PCN#20180727000.1

**Qualification of a new die prep site (Clark), die coat addition, datasheet changes,
and enhanced substrate for Group 1 devices and die coat addition only for the Group
2 devices
Change Notification / Sample Request**

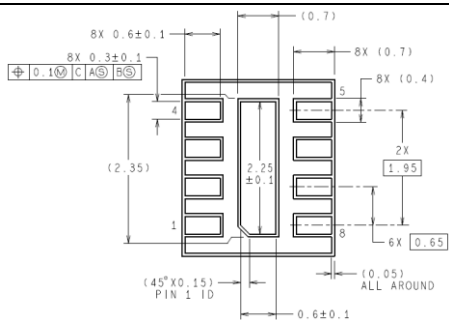
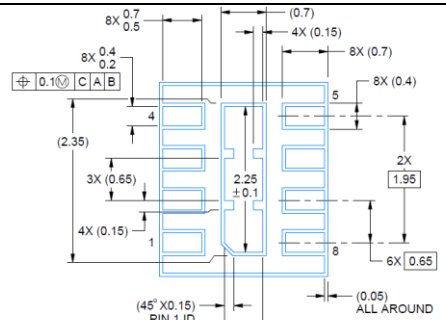
What	Current	Proposed
Die Coat	None	PI
Die Prep Site	TIEM	TI Clark
Substrate	SIL0008A	SIL0008G
Bottom Drawing
